Water Quality Report

Response to Submissions

4 MARCH 2011

Prepared for
Veolia Environmental Services

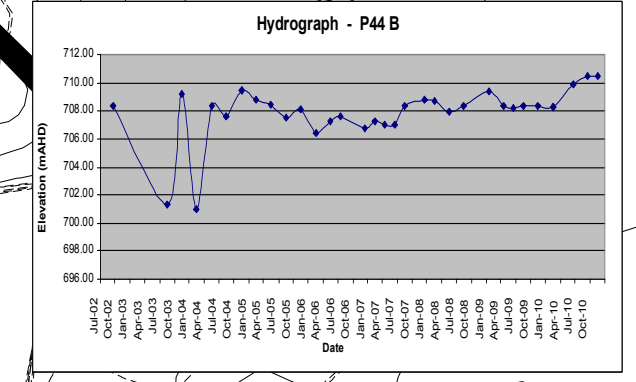
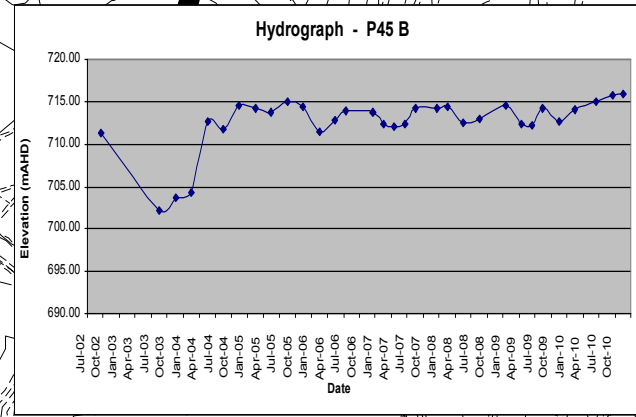
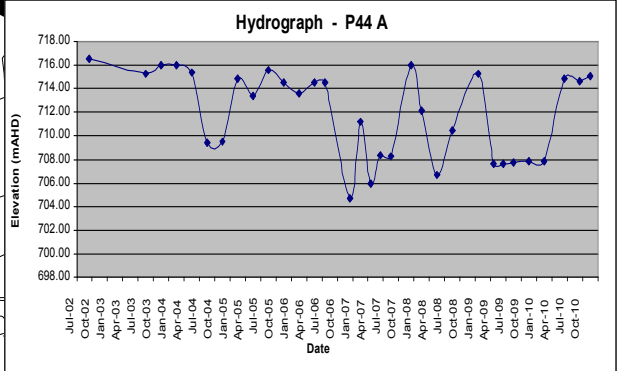
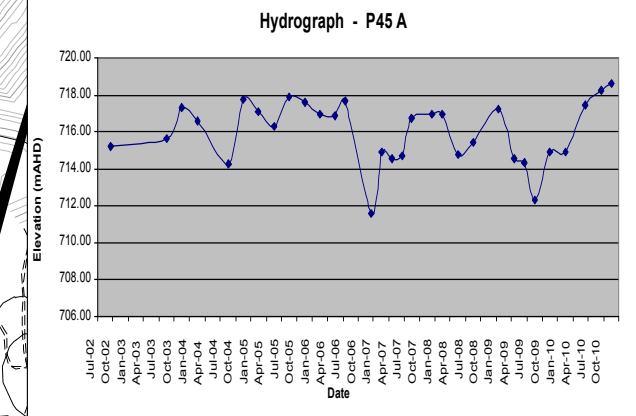
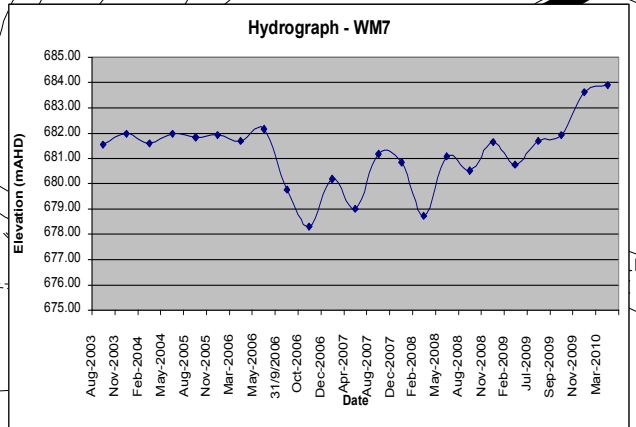
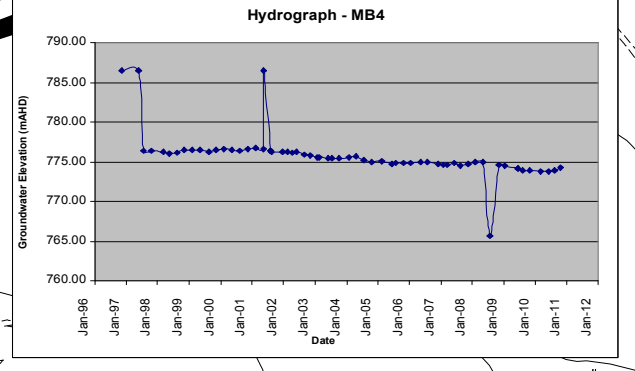
Confirmation is also requested as to the impact of the dewatering bores in relation to the groundwater level over time. It is recommended the water balance of the LMP include a graph of groundwater levels from a number of monitoring bores and this be related to the pit infrastructure and dewatering rates, and be updated as part of the Groundwater Monitoring Program.

Groundwater levels have been monitored by Veolia in bores drilled around the Woodlawn mine void since 2002. In response to the NOW submissions, hydrographs of most of the bores have been prepared. These are presented in Figure 2-14 to Figure 16 below.

Although pit dewatering has had an impact on groundwater levels, as shown in Figure 2-13, the consistent declining trend that is illustrated in some of the hydrographs between 2002 and 2009 (e.g. MB10, MB12, MB7, MB2 and MB5), is more likely a result of low rainfall conditions and lower than normal recharge rates. This is confirmed by the fact that, in 2010, this trend reversed as wetter conditions began. These hydrographs indicate that the fractured rock aquifer is responsive to vertical fluxes associated with rainfall. Horizontal permeabilities are much lower, however, as noted by the low flow rates into the mine void, and these flows are less susceptible to local climatic variability.
